Access Compliance Report Public Rights-of-Way (Curb Ramps)

Main Street: BELLWOOD_RD		Cross Street: COPA_DE_ORO_DR		Location:	SW
ADA ID: RPRK211207134033	Ramp Type:Type 1 - Perpendicular Diagonal Initial Pass/Fail: Fail		Overall Compliance: No	Severity Score:	2
Codes/Mitigation Info/Possible Solution			Field Measurements/Component Compliance

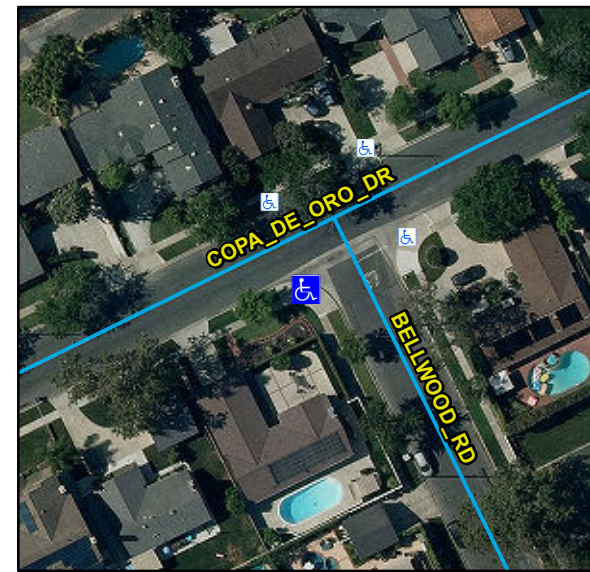
Compliance	Description	Data	Compliance	Description	Data
N/A	Ramp Length (in)	132	N/A	Flare Type LT	
Yes	Ramp Width (in)	48			N/A
Yes	Ramp Run Slope (%)	5.5	N/A	Flare Slope LT (%)	N/A
No	Ramp Cross Slope (%)	4.3	N/A	Flare Traversable LT	N/A
N/A	Landing Present	N/A	N/A	Flare Type RT	
N/A	Landing Length (in)	N/A			N/A
N/A	Landing Width (in)	N/A	N/A	Flare Slope RT (%)	N/A
N/A	Landing Run Slope (%)	N/A	N/A	Flare Traversable RT	N/A
N/A	Landing Cross Slope (%)	N/A	N/A	DWS Provided	N/A
N/A	Landing Movement Obstructed?	N/A	N/A	DWS Contrast	N/A
	Landing Movement Type	N/A	N/A	DWS Length (in)	N/A
N/A	Landing Shared	N/A	N/A	DWS Full Width	N/A
N/A	Clear Space	Yes	N/A	DWS Offset Left (in)	N/A
N/A	Clear Space To Crosswalk (in)	N/A	N/A	DWS Offset Right (in)	N/A
N/A	Marked Crosswalk 1	No	N/A	Marked Crosswalk 2	No
	Crossing 1 Direction	E		Crossing 2 Direction	N
	Marked Crosswalk 1 Width (in)	N/A		Marked Crosswalk 2 Width (in)	N/A

N/A	Ramp Inside Crosswalk 1	N/A	Yes	Ramp Inside Crosswalk 2	N/A
	Crossing 1 Slope (%)	6.5		Crossing 2 Slope (%)	3.2
	Crossing 1 Cross Slope (%)	0.4		Crossing 2 Cross Slope (%)	2.4
N/A	Gutter Ponding	N/A	N/A	Curb Slope	4.2
Yes	Gutter Lip Height (in)	0		Road Run Slope (%)	1.6
N/A	Gutter Run Slope (%)	N/A		Road Cross Slope (%)	2.2
N/A	Gutter Cross Slope (%)	N/A			
Yes	Overall Surface Condition: Acceptable		No	Perp Joint Present	No
	Cross Gutter Present?	Yes		Spandrel Present?	Yes
	Replace Cross Gutter?	No		Replace Spandrel?	No

Remove & Replace Curb Ramp With Two New Directional Ramps or Equivalent.

R204.3, R304.5.3, STD 1115
